Access Compliance Report

Public Rights-of-Way

Intersection ID: 2489	Main Street: CLARKE_CREEK_PY	Cross Street: HIGHLAND_CREEK_PY	Location: N
ADA ID: 1C6220EACC54	Ramp Type: Perp	Initial Pass/Fail: Fail	Overall Compliance: No
Severity Score: 33.75			
Codes/Mitigation Info/Possible Solution		Field Measurements/Component Compliance

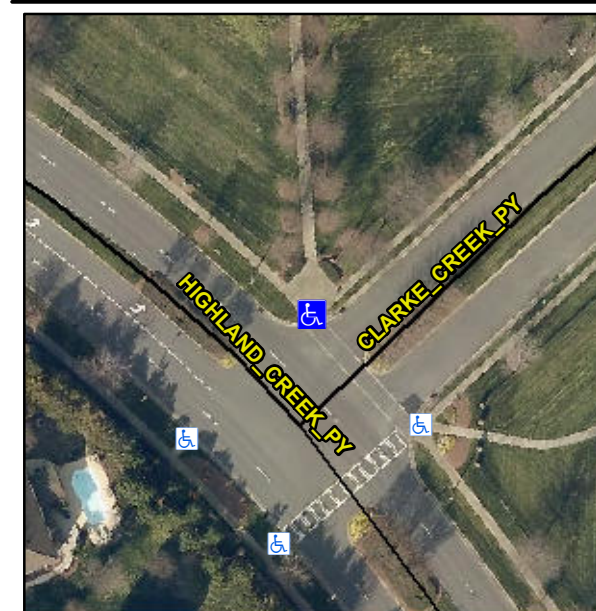
R304.5.1, R304.2.2, R304.5.3

Compliance	Description	Data	Compliance	Description	Data
N/A	Ramp Length (in)	41.0	No	Ramp Slope (%)	9.1
No	Ramp Width (in)	42.0	No	Ramp XSlope (%)	6.3
N/A	Flare Type LT	N/A	N/A	Flare Type RT	N/A
N/A	Flare Slope LT (%)	N/A	N/A	Flare Slope RT (%)	N/A
N/A	Flare Traversable LT?	N/A	N/A	Flare Traversable RT?	N/A
N/A	Landing Length (in)	N/A	N/A	DWS Provided?	N/A
N/A	Landing Width (in)	N/A	N/A	DWS Contrast?	N/A
N/A	Landing Slope (%)	N/A	N/A	DWS Length (in)	N/A
N/A	Landing X Slope (%)	N/A	N/A	DWS Full Width?	N/A
N/A	Landing Curb? (Y/N)	N/A	N/A	DWS Offset (in)	N/A
N/A	Shared Landing?	N/A			
N/A	Gutter Ponding?	N/A	N/A	Gutter Slope (%)	N/A
N/A	Gutter Lip Ht (in)	N/A	N/A	Gutter X Slope (%)	N/A
N/A	Painted X Walk1?	Yes	N/A	Painted X Walk2?	N/A
	X Walk 1 Direction	To SE		X Walk 2 Direction	N/A
N/A	X Walk 1 Width (in)	97.0	N/A	X Walk 2 Width (in)	N/A
	X Walk 1 Slope (%)	3.0		X Walk 2 Slope (%)	N/A
	X Walk 1 X Slope (%)	5.2		X Walk 2 X Slope (%)	N/A

Remove & Replace Entire Ramp.
